RE: DEIR Comments

General Electric Company ("GE") is pleased to submit these comments on EPA's February 1997 Data Evaluation and Interpretation Report ("Report") for the Hudson River PCBs Reassessment Remedial Investigation/Feasibility Study.

COMMENTS OF GENERAL ELECTRIC COMPANY ON

PHASE 2 REPORT - REVIEW COPY  
FURTHER SITE CHARACTERIZATION AND ANALYSIS  
VOLUME 2C -  
DATA EVALUATION AND INTERPRETATION REPORT  
HUDSON RIVER PCBs REASSESSMENT RI/FS  
FEBRUARY 1997

Figure 23. Probability distribution of PCB congener dechlorination ratio in 1993 NOAA fish samples.

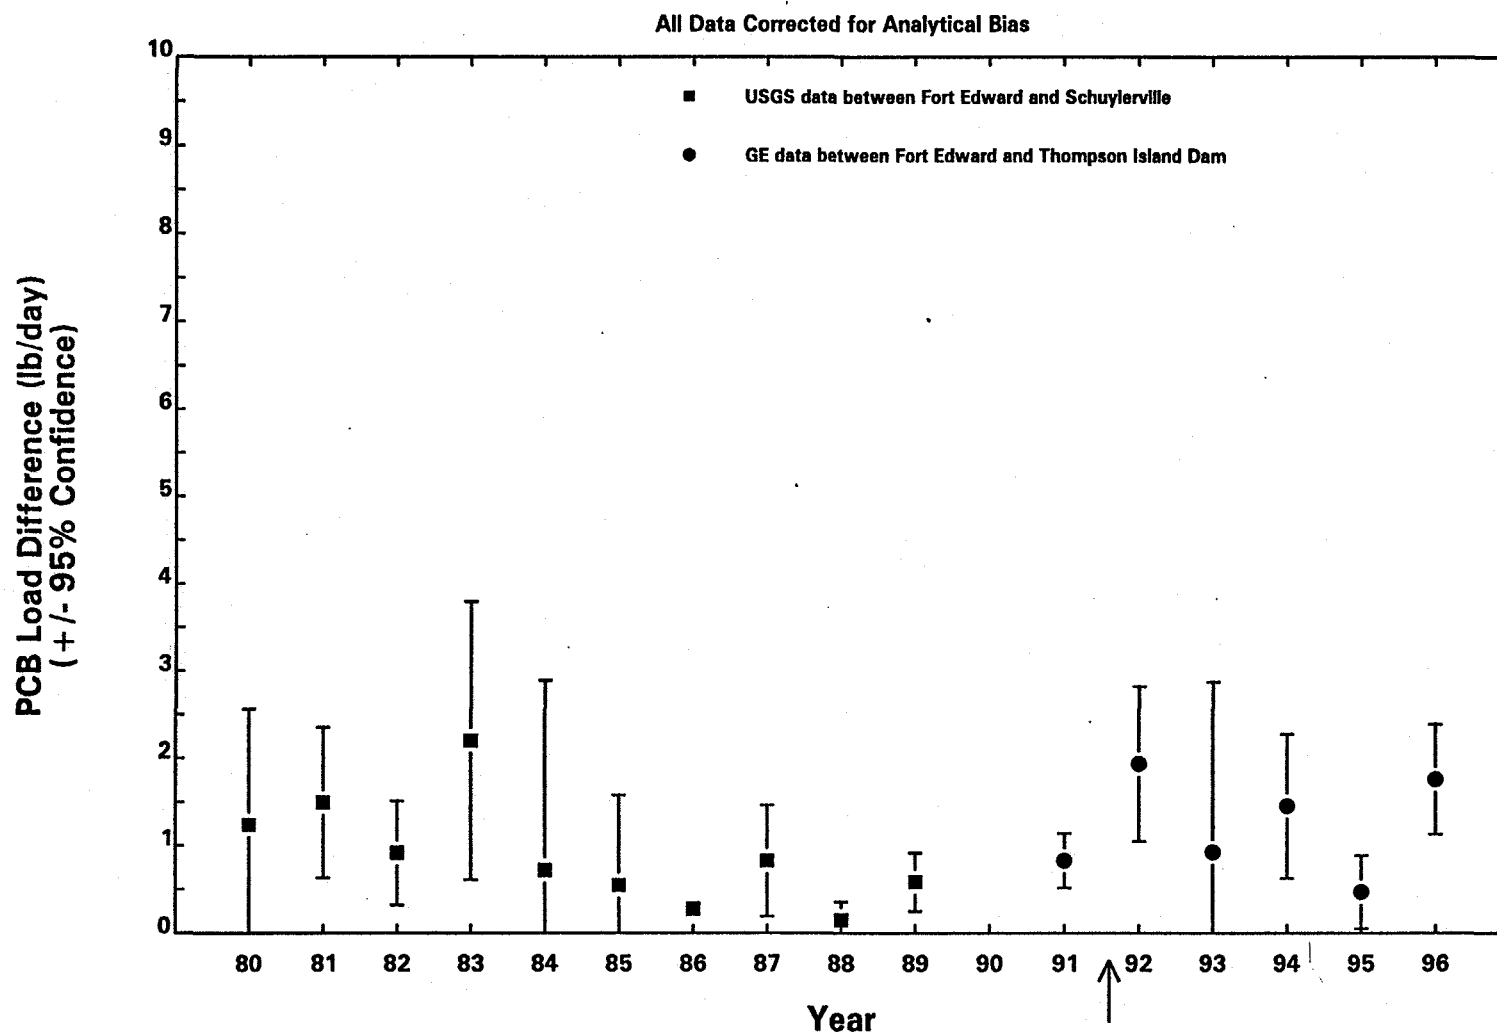
Figure 23 presents the values of these four ratios in fish collected from the TIP by NOAA in 1993. Comparison of the fish ratios with the sediment ratios in Figure 22 indicates that slightly

Figure 28. Predicted average June-August 1993 Hudson River PCB loading profile (river mile 195 - 155).

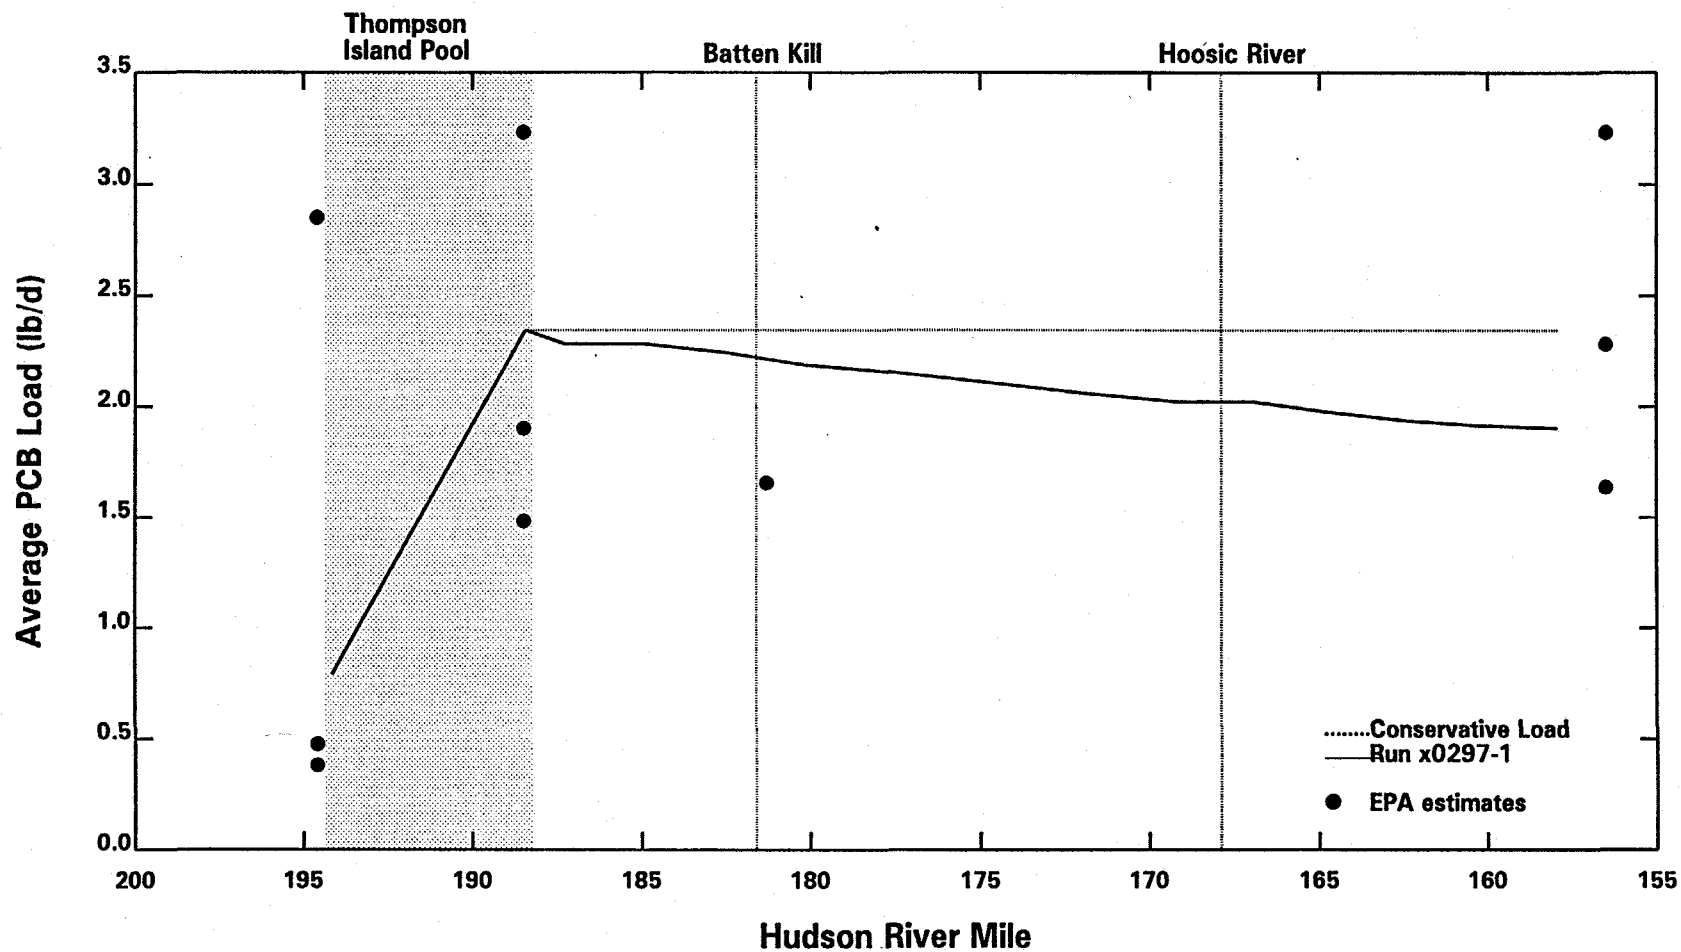
Figure 28 compares the three EPA estimates of loading through the Upper Hudson River for the June to August 1993 period with the model simulation for the same period. The dashed-line profile represents the conservative transport of PCBs that EPA claims exists from the TID to Troy. The model shows a 19% loss of PCBs in the downstream direction that is the net result of volatilization, net deposition of solids and sorbed PCBs, and the addition of PCBs to the water column from downstream sediments and, to a lesser degree, by downstream tributary inputs. This net loss is small enough to be within the uncertainty bounds of the data. The EPA data collection in the summer of 1993 found an approximately 20% increase in the PCB load between the TID and Waterford. This was a period during which the increase in the PCB load across the TIP reflected the impact of the Allan Mill release. Conditions downstream of the TID may also have been influenced by the same event.

Figure 29. Predicted settling and volatilization components of average June-August 1993 Hudson River PCB loading profile (river mile 195-155).

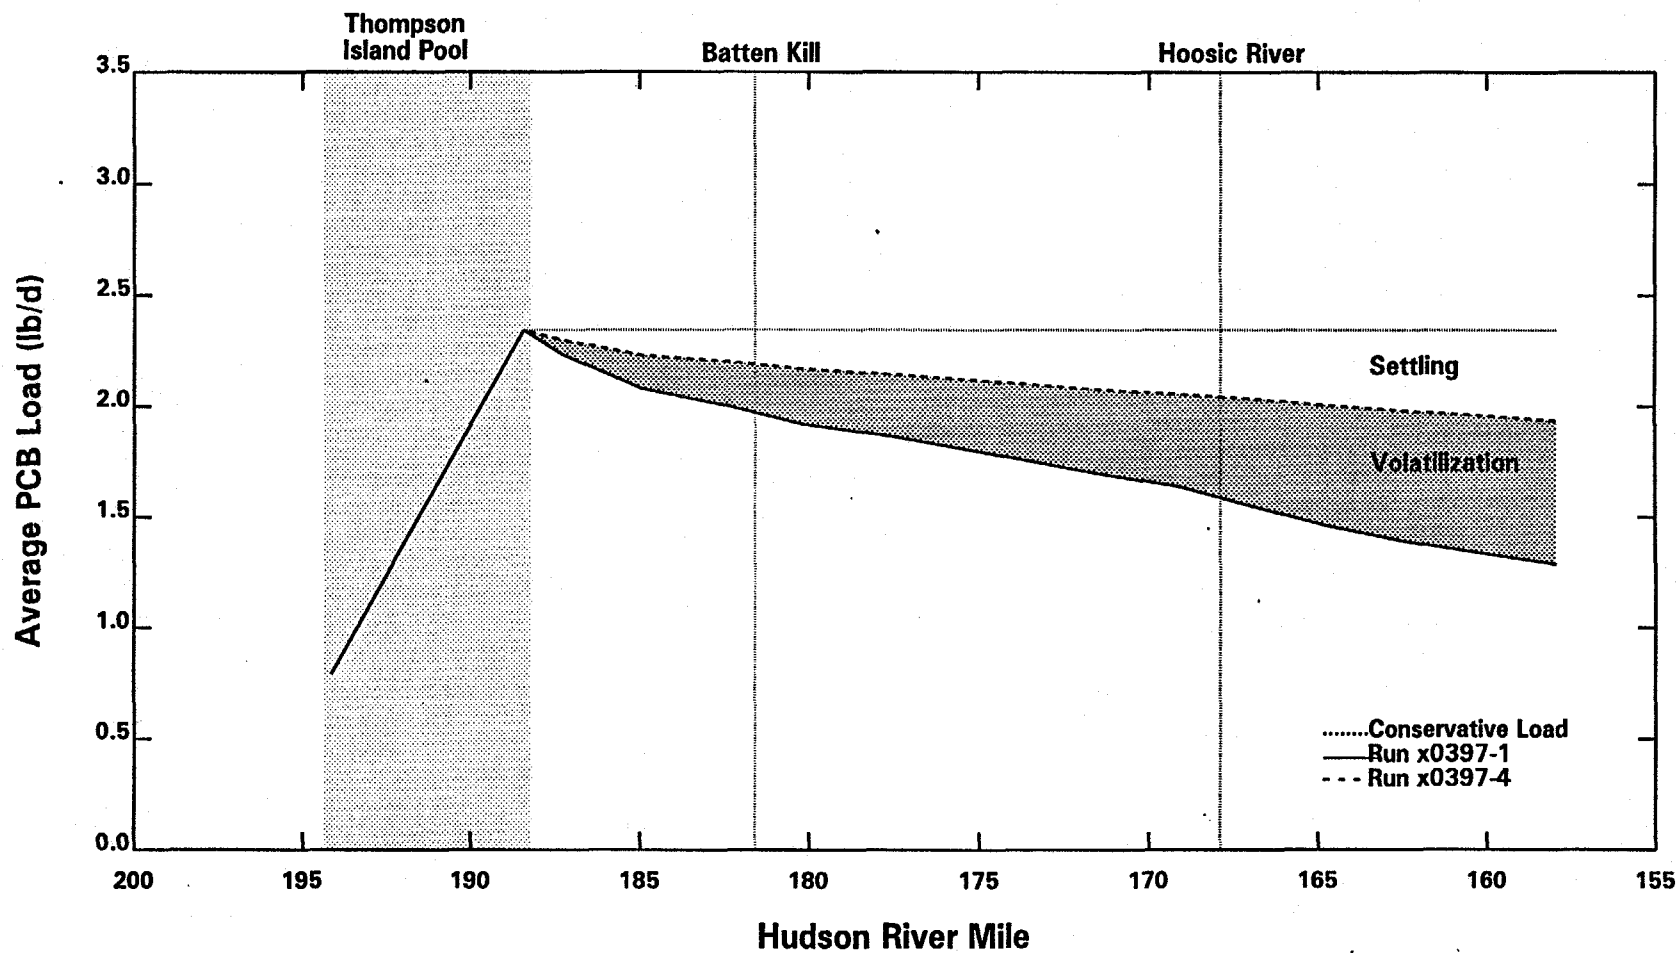
Figure 29 provides further clarification of the origins and fate of the TID PCBs in the river during this period. Here, the lower limit of the shaded region represents the profile of water column PCB load without a sediment source in Reaches 1-7. PCB load in the river decreases by 45.1% between Thompson Island Dam and Waterford. This decrease is a result of the combined effects of settling (the unshaded region, 17.4%) and volatilization (the shaded region, 27.6%). Considering the results of Figures 28 and 29 together, the sediments in Reaches 7 - 1 contribute 32.3% to the

Figure 30. Absolute amount of chlorines removed from PCBs as a function of concentration.

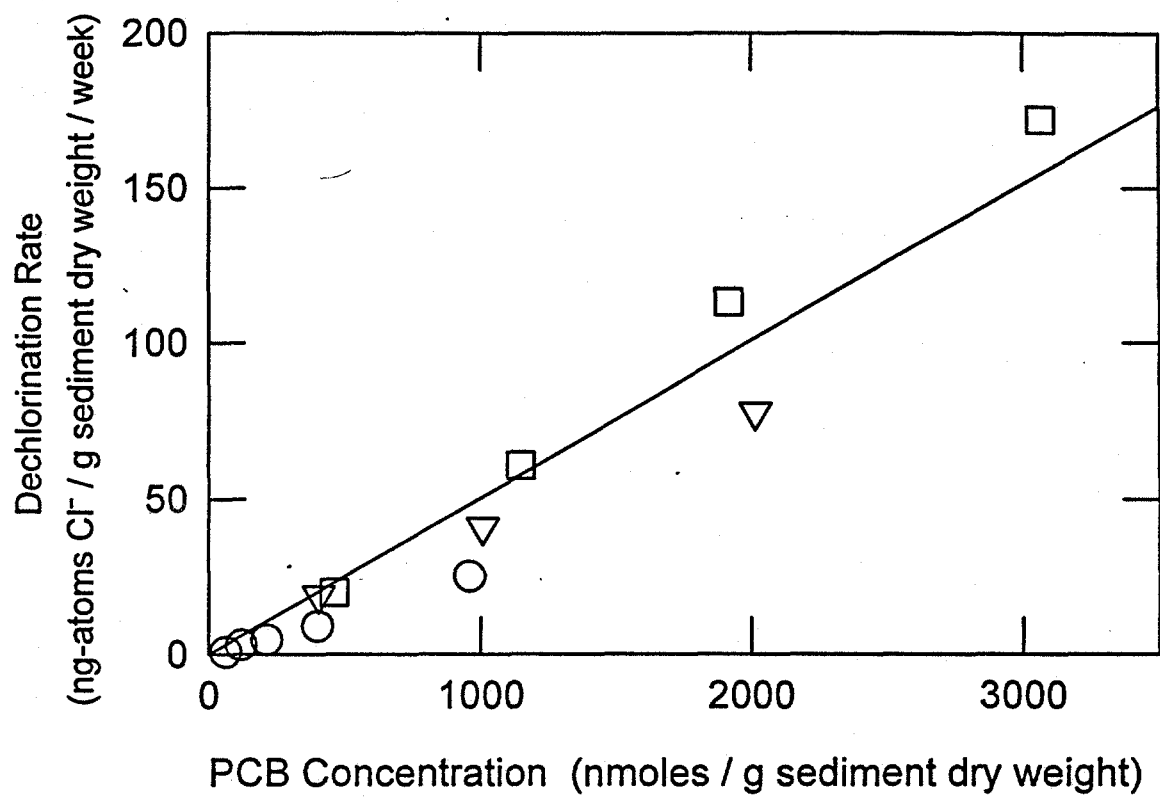
Numerous studies in the laboratory and the field have detected anaerobic PCB dechlorination over a broad range of concentrations (reviewed in Bedard and Quensen, 1995). Figure 30 shows that anaerobic PCB dechlorination has been observed in controlled laboratory studies at concentrations as low as 10 ppm (Abramowicz *et. al.*, 1993; Fish, 1996, Rhee *et. al.* 1995). Taken together, the studies demonstrate that there is a linear relationship between PCB concentration and dechlorination rate without a threshold concentration.

Figure 31. Intra-homologue PCB dechlorination peak ratio as a function of PCB concentration.

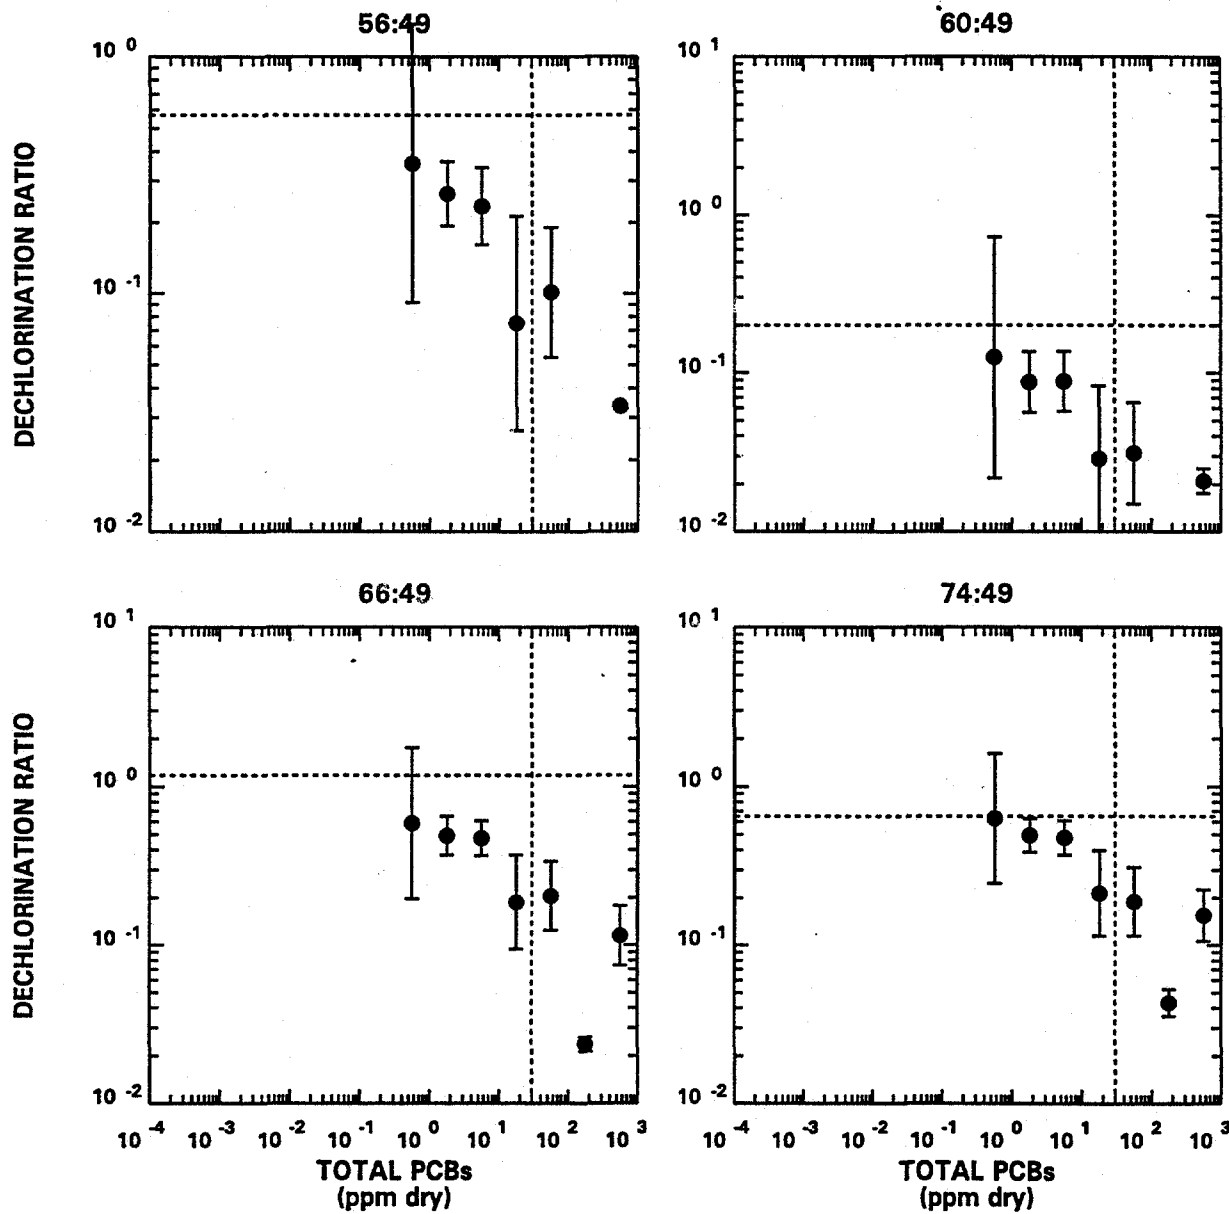
The use of intra-homologue peak ratios to assess dechlorination at various PCB concentrations is shown in Figure 31. Four peak ratios are utilized (BZ 56/49, 23-34-/24-25-CB; BZ 60/49, 234-4-/24-25-CB; BZ 66/49, 24-24-/24-25-CB; BZ 74/49, 245-4-/24-25-CB). These ratios represent the change in the dechlorination sensitive tetrachlorobiphenyls (mono-*ortho* substituted) to the more resistant tetrachlorobiphenyl congener 24-25-CB (di-*ortho* substituted). The result of this peak ratio analysis demonstrates that significant dechlorination occurs at all concentrations, even at sub-ppm levels. There is also a clear trend demonstrating more extensive dechlorination at higher PCB concentrations, consistent with laboratory experiments.

Figure 32. Intra-homologue PCB dechlorination peak ratio as a function of sediment depth for core segments with total PCB less than 30 ppm.

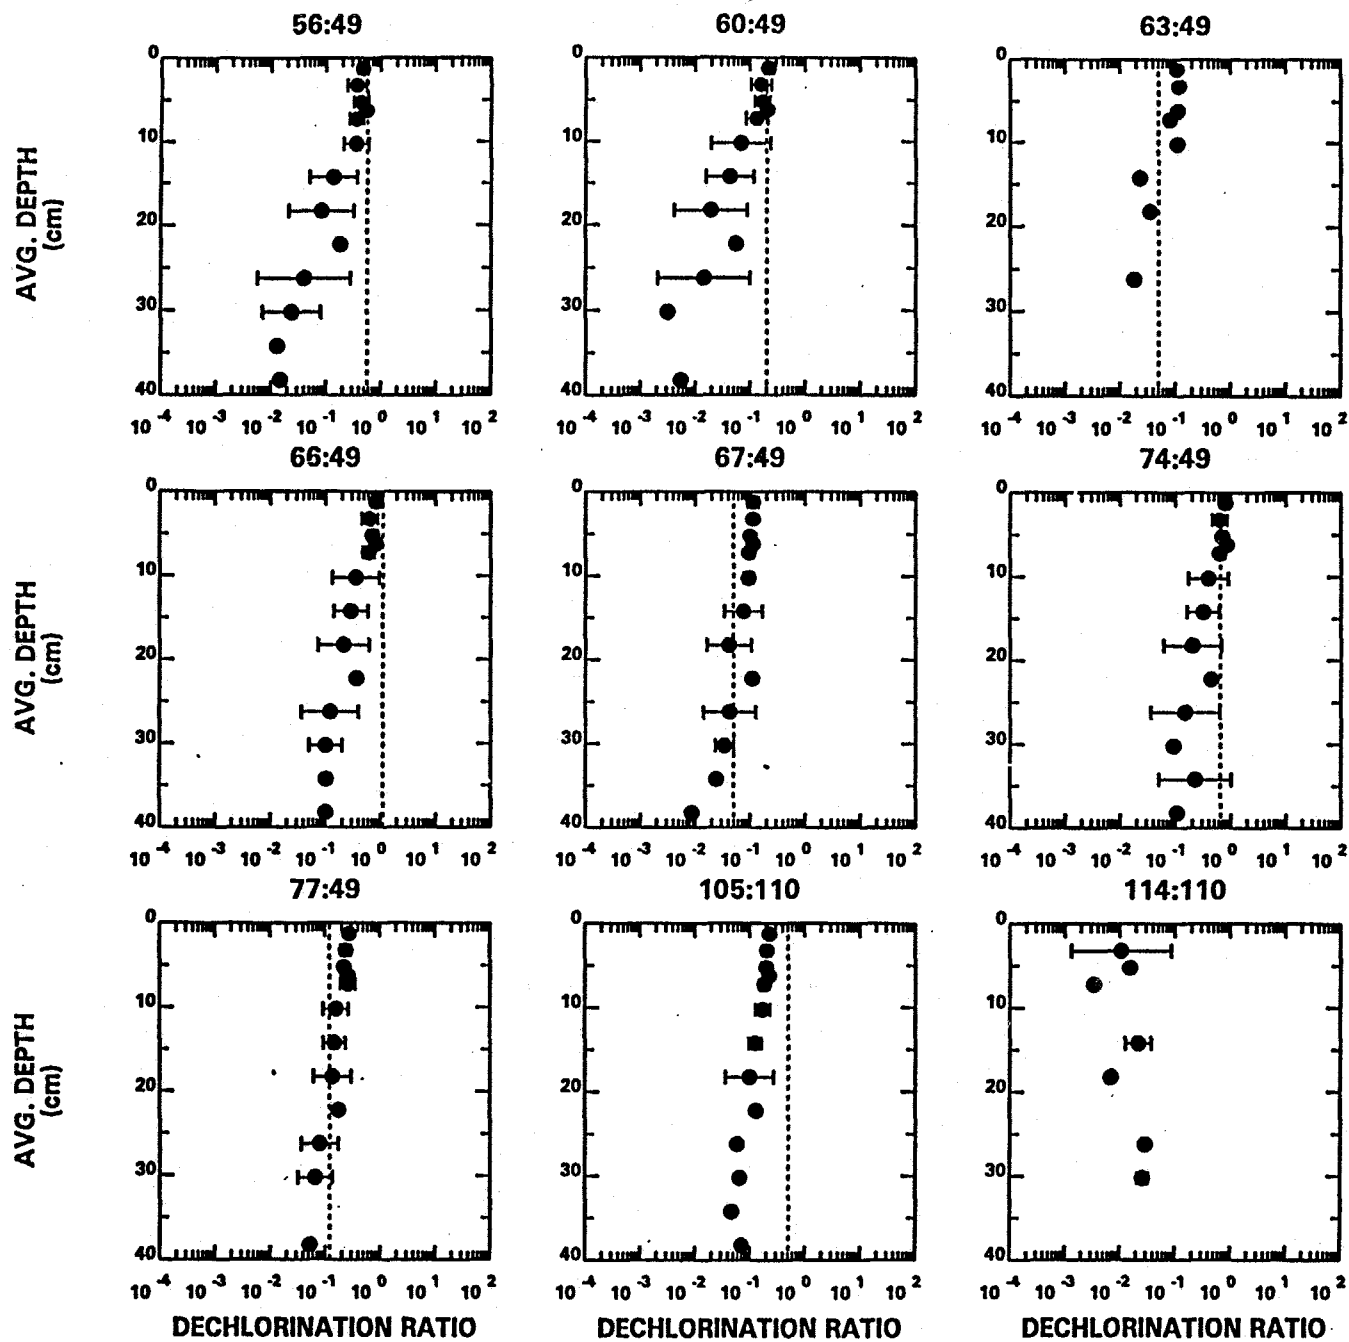
Additional evidence to demonstrate that dechlorination is still occurring in the upper Hudson is found in Figure 32. This Figure represents the application of the intra-homologue peak ratios to the EPA Phase 2 high resolution sediment cores. To minimize the impact of concentration on the rate of dechlorination, only a narrow concentration range was utilized (all 3-30 ppm core segments from all Upper Hudson high-resolution cores). Note that the extent of dechlorination continues to change in a smooth continuum with increasing depth in the core. This data demonstrates that the extent of dechlorination strongly correlates with increasing depth and increasing age of the sediment,
